# CITY OF ALBUQUERQUE

**Re: McDonald's at Candelaria / Eubank, 9515 Candelaria,  
Traffic Circulation Layout  
No Engineer's Stamp provided (G20-D031)**

**Re: McDonalds, 9515 Candelaria NE**  
**Grading and Drainage Plan**  
**Engineer's Stamp dated 5/3/11 (G20/D031)**

## Narrative of City Comments

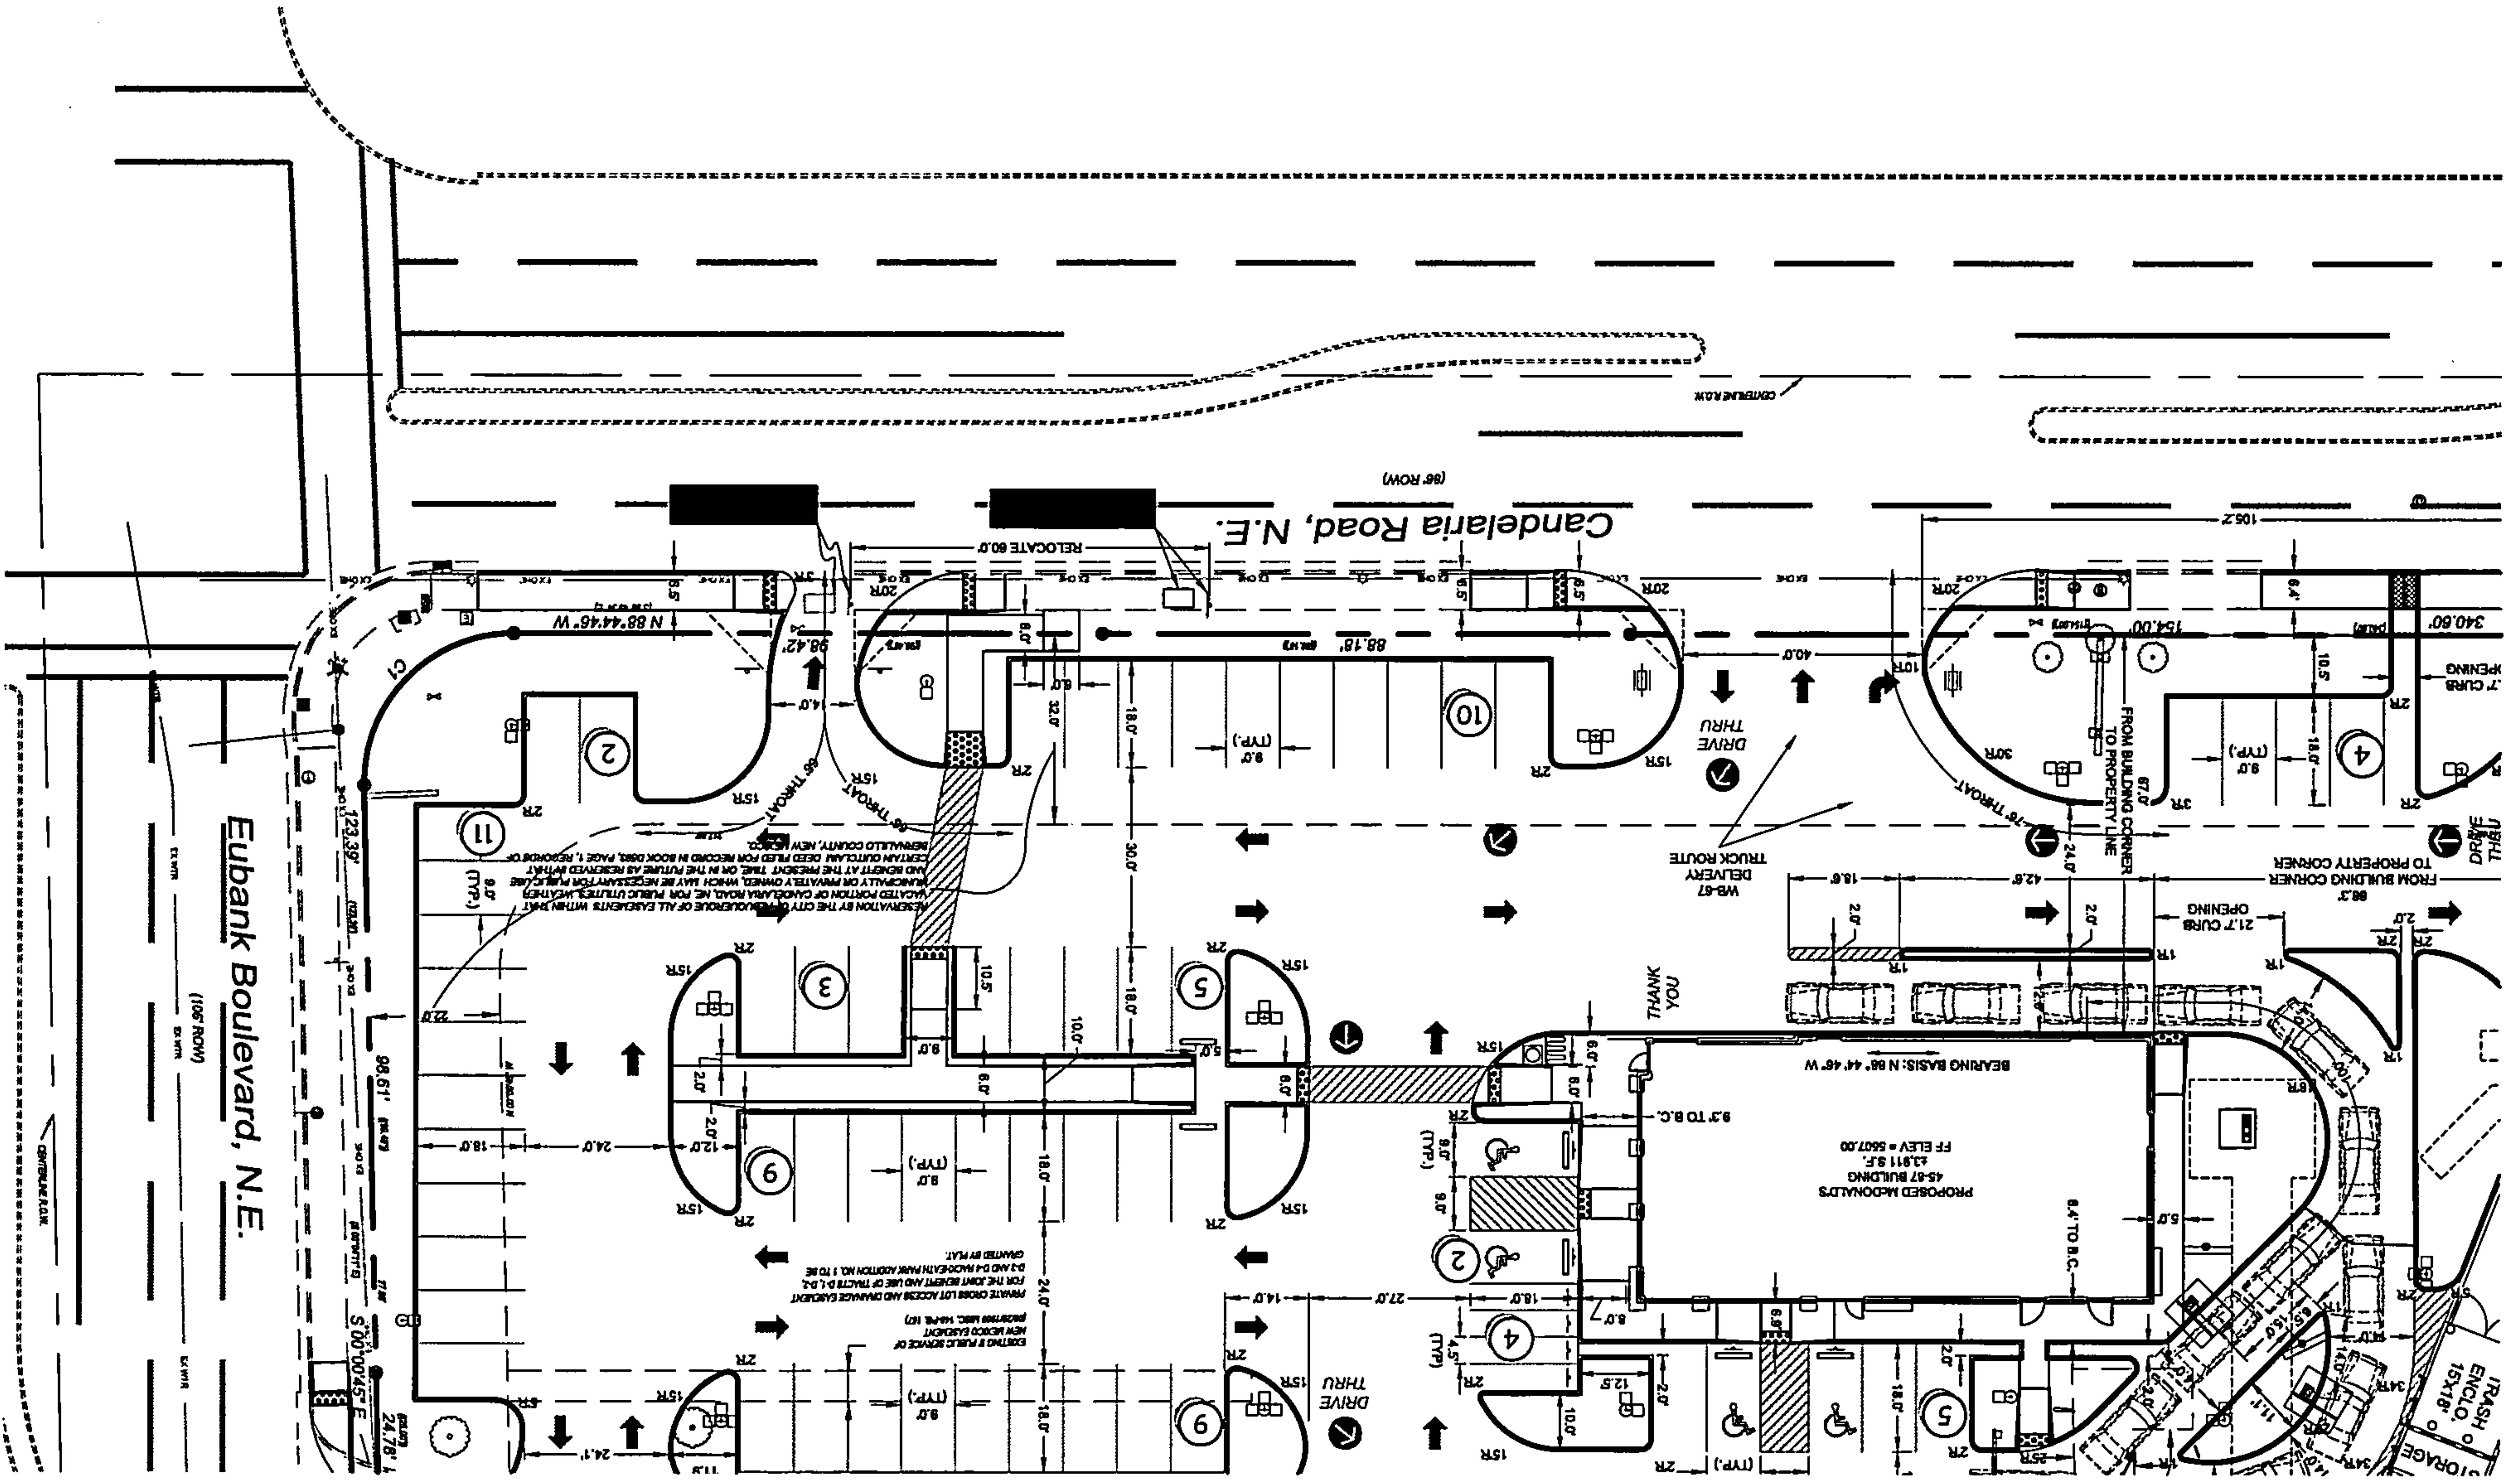
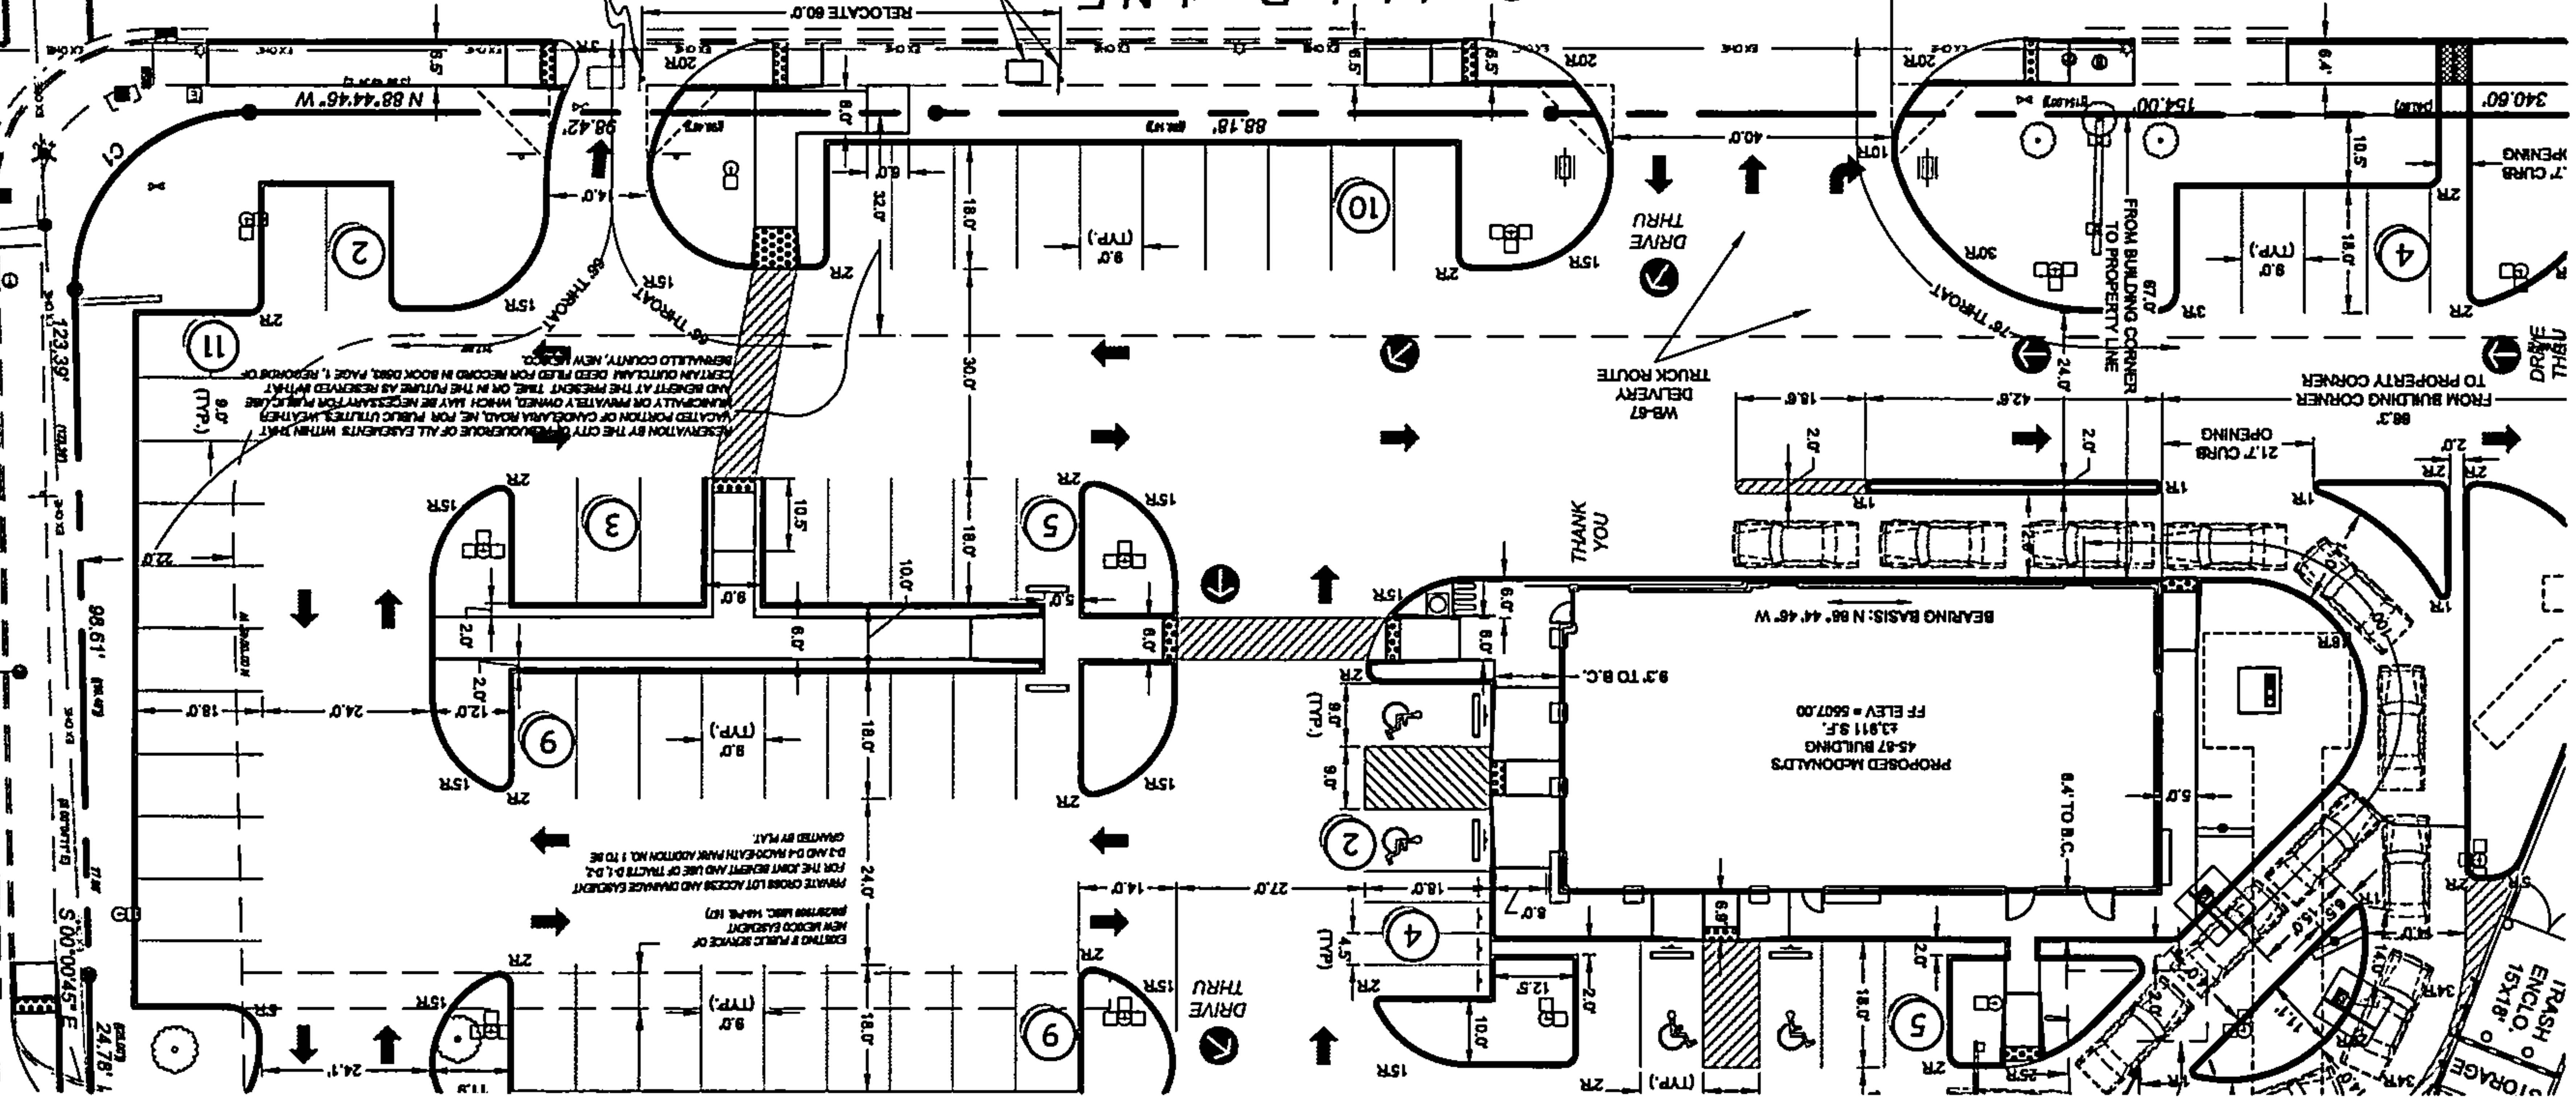
May I ask what process we must begin in order to request the relocation of a bus stop sign? If allowed, we would like to move it about 45' west along Candelaria.

We're fine with moving the stop from it's current location - we still have someone doing a site visit to verify whether we want to move the stop west, as proposed, or east between the driveway and Eubank, but you can let Kristal Metro know we're fine with moving the stop out of the planned driveway.
